## MEMORANDUM

**SUBJECT:** Supplemental Addendum to the Response to Comments (RTC) Document and Final Environmental Impact Report (EIR) for the Northgate Mall Redevelopment Project (State Clearinghouse #2021120187)

This memorandum is an Addendum to the RTC Document and Final EIR prepared for the proposed Northgate Mall Redevelopment Project (project). The Draft EIR for the proposed project was published on February 13, 2024 and the public comment period closed on March 5, 2024. The RTC Document and Final EIR were published on October 18, 2024 and a hearing was held before the City of San Rafael (City) Planning Commission to recommend certification of the Final EIR on October 29, 2024. Since publication of the Final EIR, the City determined that, due to technological and file transfer errors, a total of 21 comment letters submitted on the Draft EIR during the public comment period were not acknowledged or responded to in the Final EIR. This Addendum therefore includes and provides responses to each individual letter received but previously omitted in the Final EIR and is incorporated as Appendix C to the Final EIR.

## EXHIBIT 2

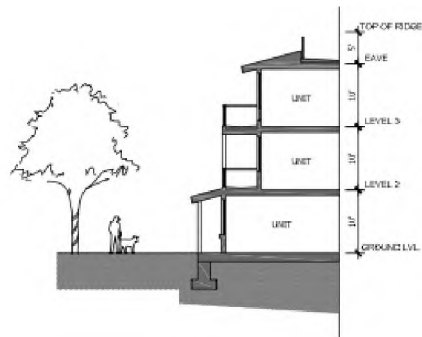
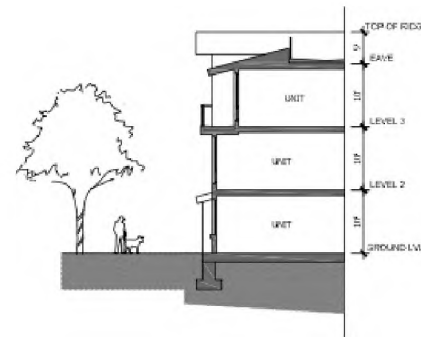
- The decks in Residential 2 Unit Plans (or types) 2, 3, and 4 have balconies or decks at the Level 3 floor level – that is, 20 feet above ground level (*see* plans RE-22; RE-26). Attached as **Exhibit 2** is a copy of Plan RE-22 showing the height above ground of the windows and decks of the buildings in Residential 2. This includes units that look out over Northgate Drive.

This comment expresses specific concerns related to the potential loss of privacy for individual residents in the vicinity of the project site. The comment cites the City's General Plan (specifically Policy LU-3.2) and Design Guidelines to claim that the Draft EIR does not adequately identify and mitigate significant impacts to nearby residential uses. This concern is noted and addressed below in the context of General Plan policy consistency; however, as discussed in Response B-8B-5 of the RTC Document, loss of privacy is not a CEQA impact. Impacts under CEQA focus on direct and indirect physical impacts to the environment.

In addition to the actions cited in the Draft EIR regarding City General Plan Policy LU-3.2, the policy recognizes, "While these principles are fundamental, they do not preclude neighborhood change. Neighborhoods are dynamic places, and should adapt to changing tastes, styles, technology, and needs as they evolve." Per the City's General Plan (page 3-2), "The land use goals and policies are underpinned by a basic belief that change is both inevitable and necessary and should be harnessed to achieve the vision of a thriving city."

# EXHIBIT 6

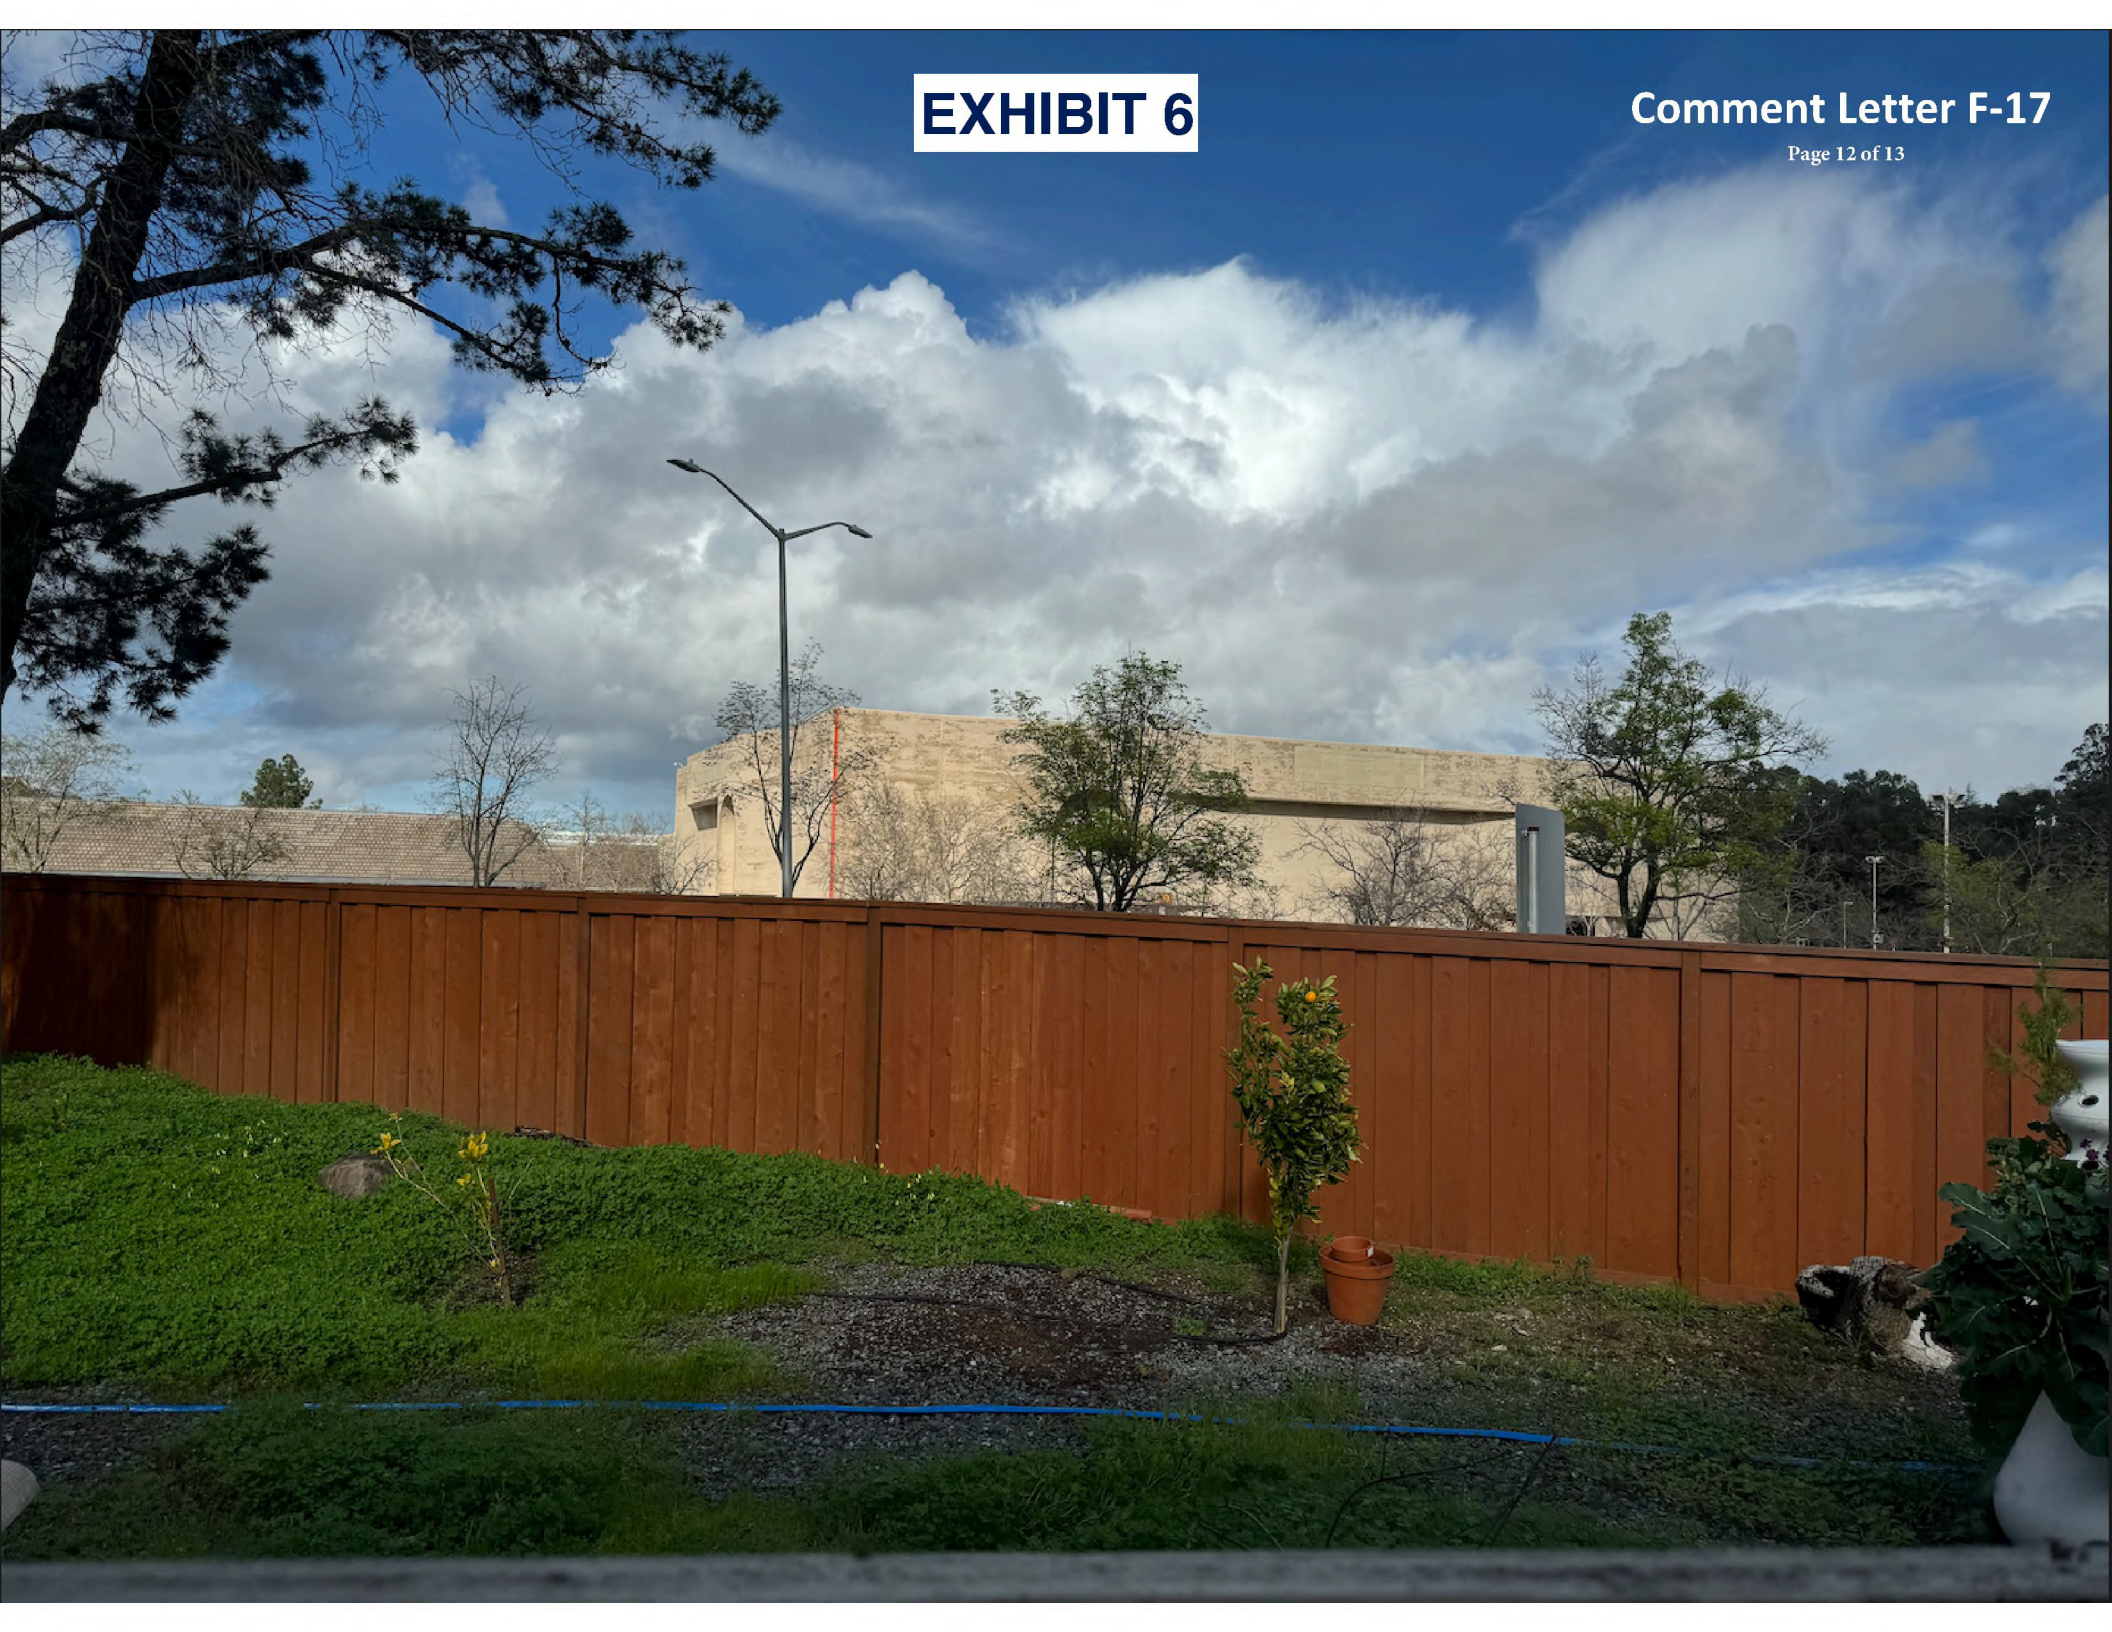
during winter and will provide virtually no privacy at their tops even during summer. Additionally, it will take years for these trees to grow to that height and fill out. In sum, these trees will not block the view across Northgate Drive into my yard or windows. Attached as **Exhibit 4** is a copy of Plan RE-27 showing the height of the planned trees on the project side of Northgate Drive.
